**Sandia National Laboratories**

Enclosed is the summary of activities during January 1987 for FIN# A1165. If you have any questions please feel free to contact me at (FTS) 844-8368 or Robert Guzowski at (FTS) 844-3583.

PROGRAM: Licensing-Methodology Assistance

FIN#: A-1165  
Task I

Figure 1. Components of performance assessment.

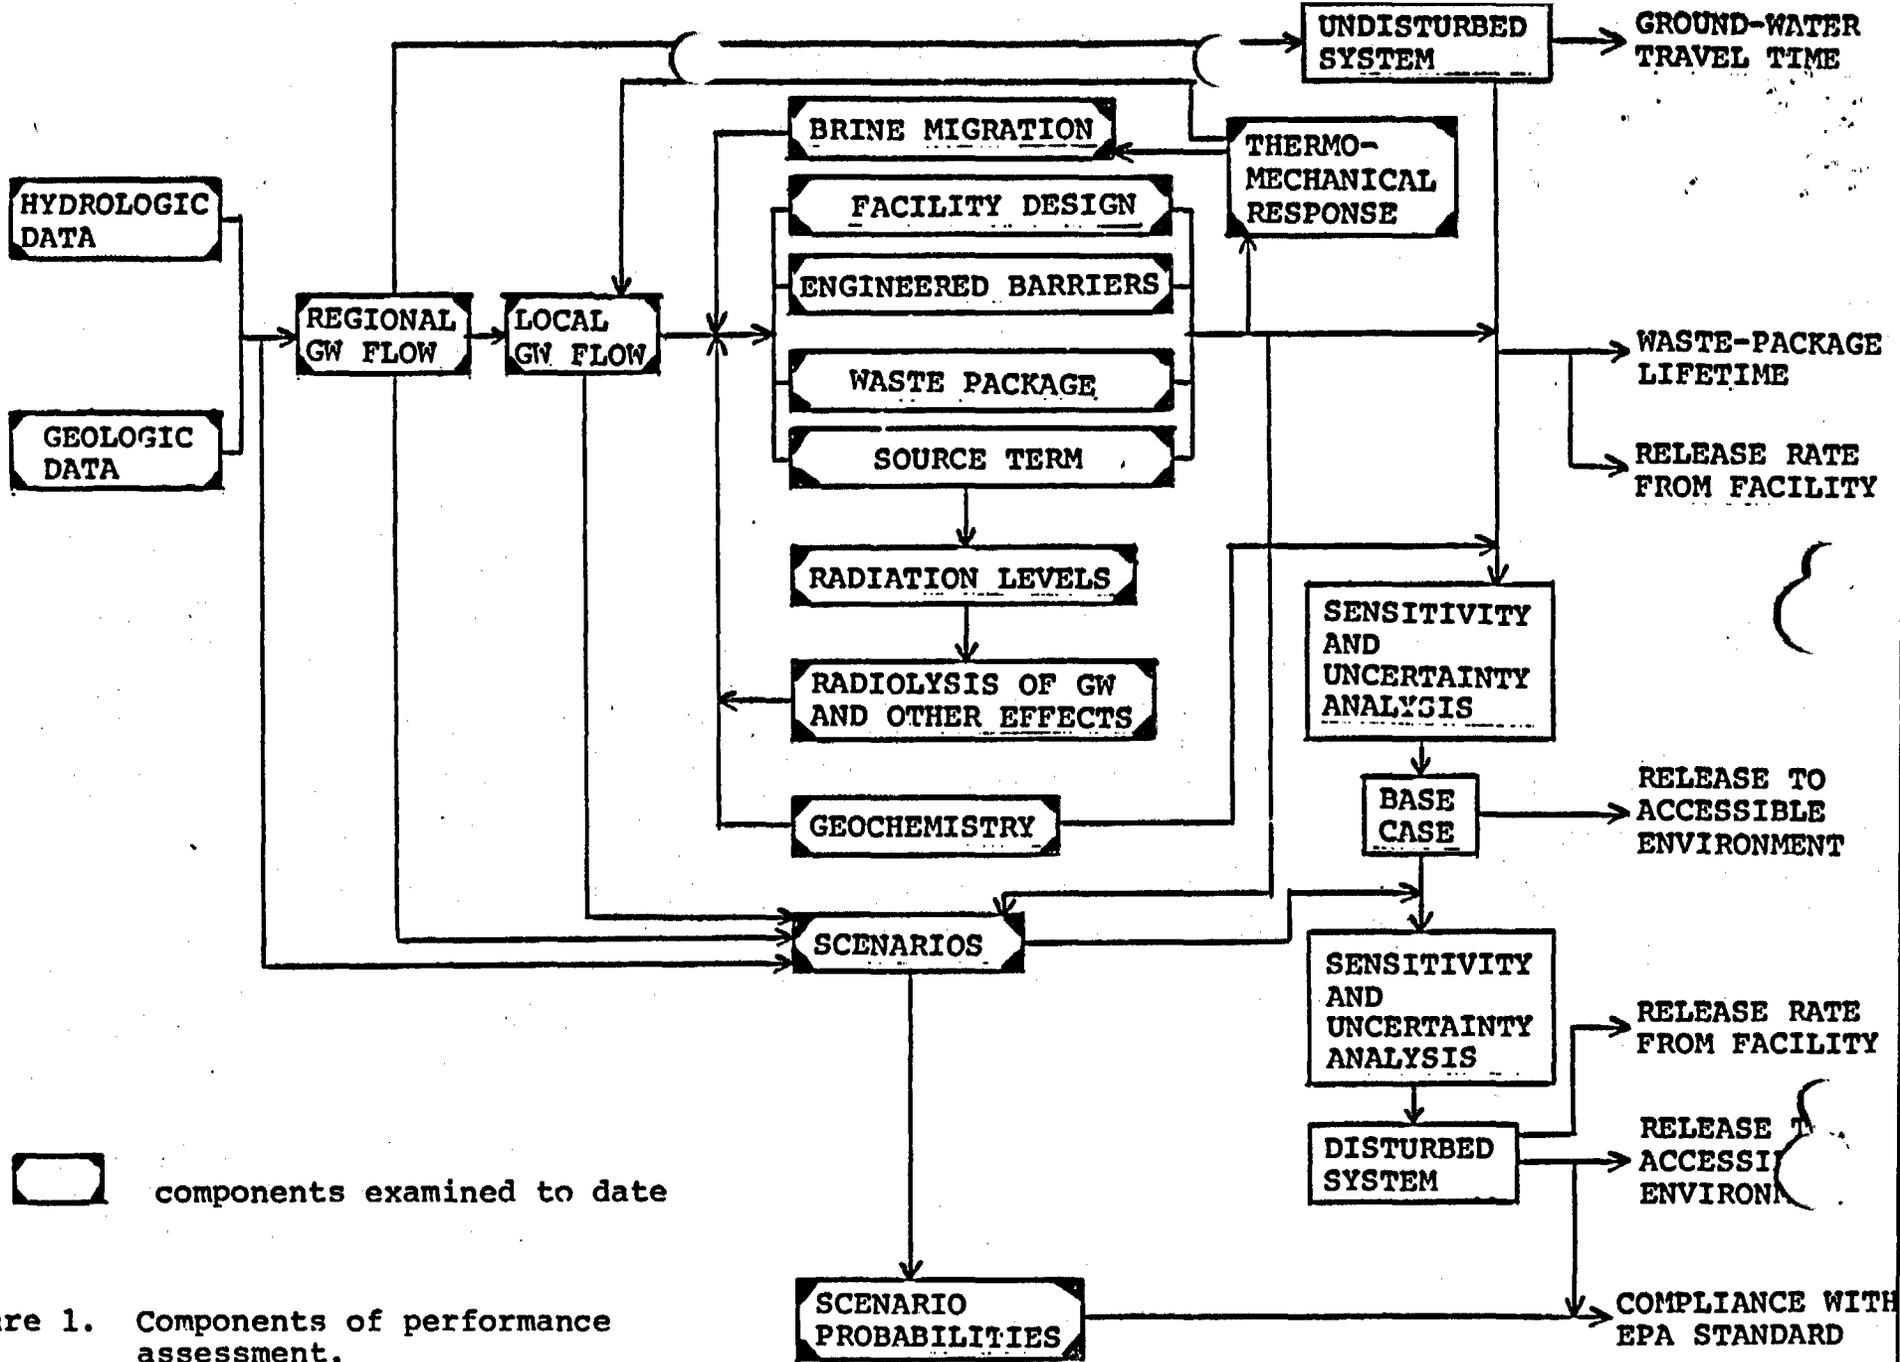
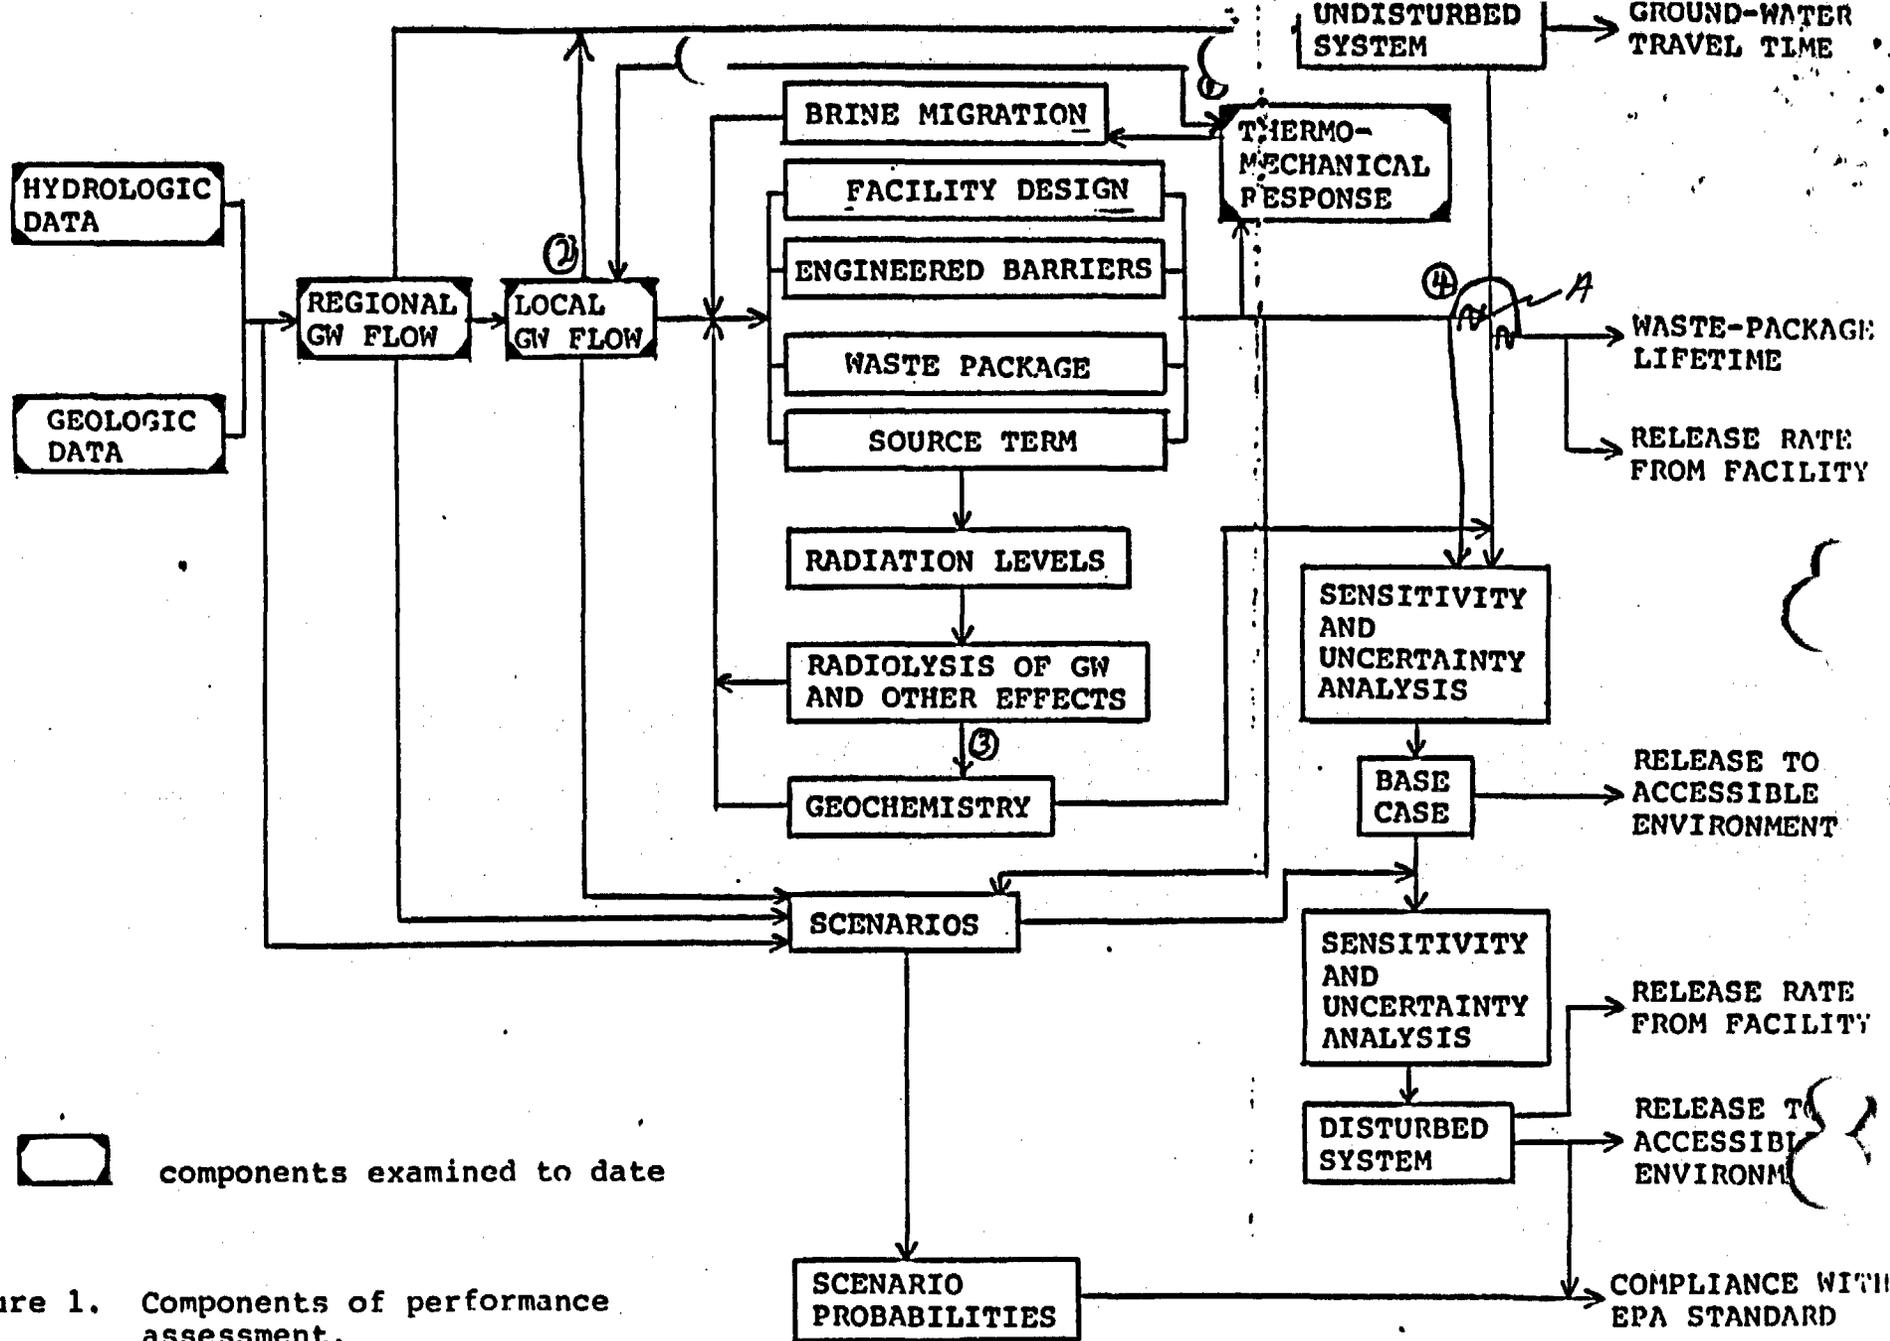
With respect to your comments on the November monthly, Figure 1 was a preliminary effort at defining the components of a performance assessment and their interrelationship. Suggestions as to modifications and/or improvements are encouraged. In response to the specific comments:

1. The input into the Thermomechanical (TM) Response component is dependent on the Brine Migration down through Geochemistry components. In addition, these components and the TM Response require input from the Local Ground-Water Flow component. Having the Local Flow feed into the Facility-Design through Source-Term bracket is meant to indicate that the Local Flow is an important contributor to all components to the right of the Local Flow box. TM Response is dependent on the facility and waste being present. As a result, Local Flow must be through the facility rather than directly into TM Response.

2. Local Flow should feed directly into the Undisturbed System. Because the Local Flow will be used to determine ground-water travel time, and Regional Flow is used to determine Local Flow, an arrow connecting Local Flow and the Undisturbed System should replace the Regional Flow-Undisturbed System connection.

3. The intent of the arrow from Radiolysis to the line from Geochemistry to Local Flow was to show that Radiolysis could be considered with or without geochemistry. Inclusion of the additional arrow between Radiolysis and Geochemistry should make this intent clearer.

4. For the reasons pointed out in the comment, the addition of a Very Near-Field component has been considered immediately to the right of Local Flow. A box at this location hopefully would be interpreted as meaning that all of the Very Near-Field data and output would be present at Junction A (see figure). Sensitivity And Uncertainty Analysis could be moved to a location between Junction A and the arrow to Waste-Package Lifetime. These modifications are under consideration.
